License No. DPR-35
Docket No. 50-293

Revision 1 to Reload 6 Licensing Submittal

**GENERAL ELECTRIC BOILING WATER
REACTOR SUPPLEMENTAL RELOAD
LICENSING SUBMITTAL FOR
PILGRIM NUCLEAR POWER STATION
UNIT 1, RELOAD 6**

PILGRIM NUCLEAR POWER STATION, UNIT 1
RELOAD 6

Figure 2a. Plant Response to Load Rejection Without Bypass,
100% Power, 107.5% Flow at BOC + 6000 MWd/ST

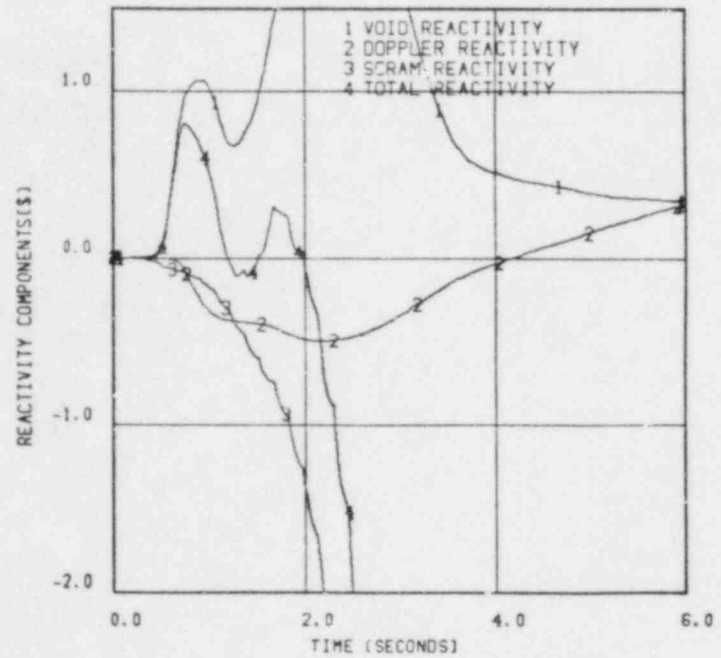
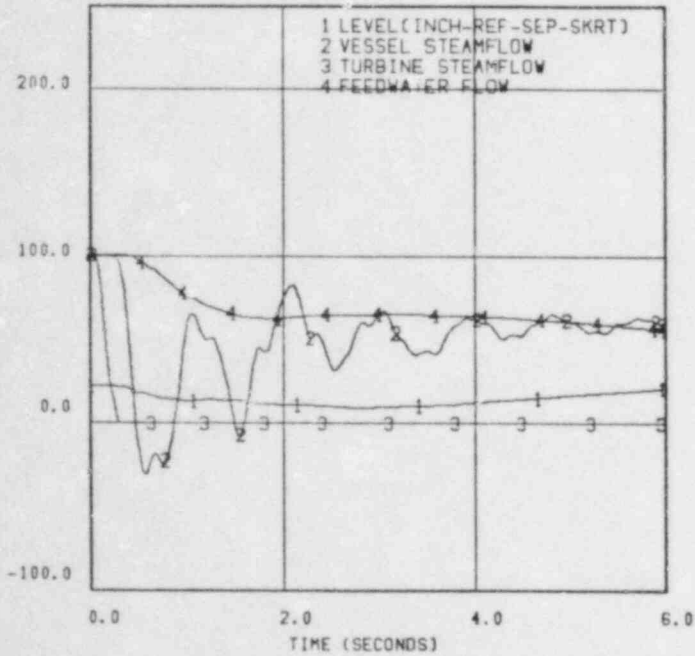
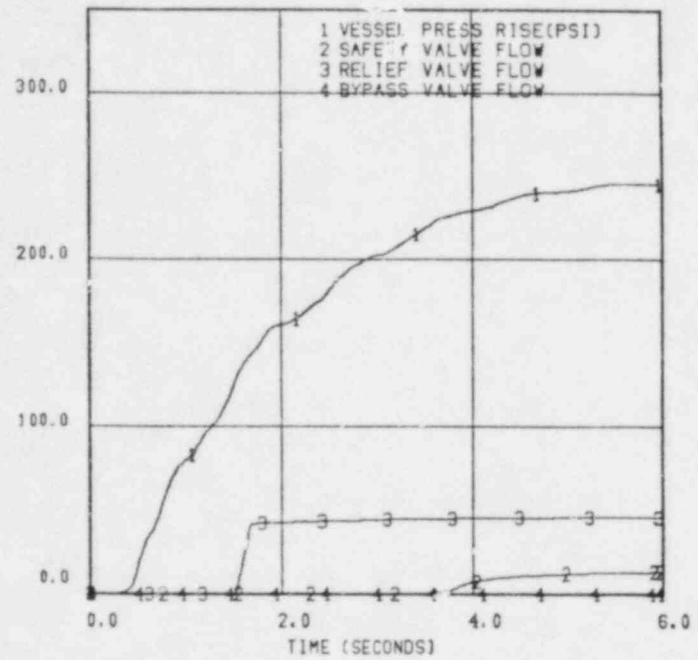
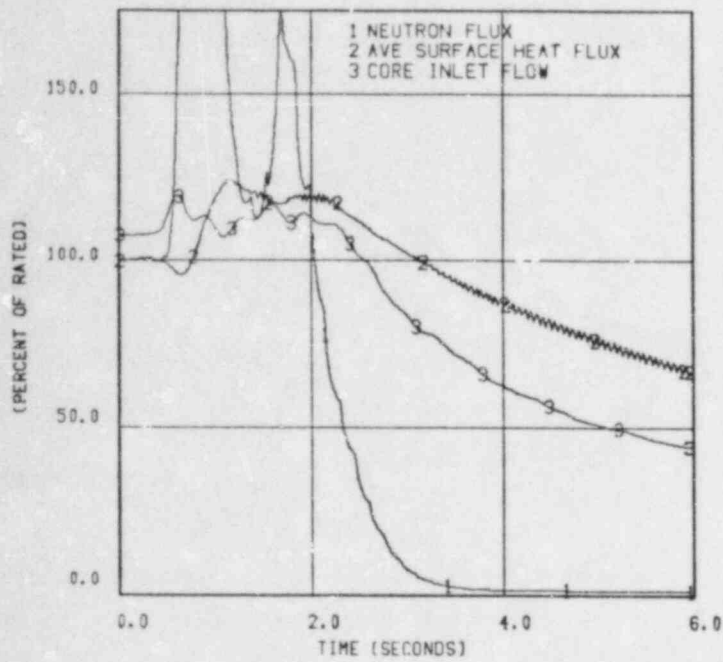
The General Electric Supplemental Reload Licensing Submittal for the Pilgrim Nuclear Power Station was submitted by letter from W. D. Harrington to D. B. Vassallo, dated December 28, 1983 (BECO 83-301). In this letter, we identified an error that was noted on Page 13 of the reload licensing submittal. This error involved the upper right hand graph in Figure 5, Plant Response to MSIV Closure, 100% Power, 107.5% Flow (Page 13). Specifically, Curve 3 of this graph was labeled the relief valve flow curve, but it actually represented the sum of safety and relief valve flows.

The attached revision to this reload licensing submittal corrects the error noted on Page 13 and is submitted for your use. Correction of this error does not affect the conclusions of the reload licensing submittal.
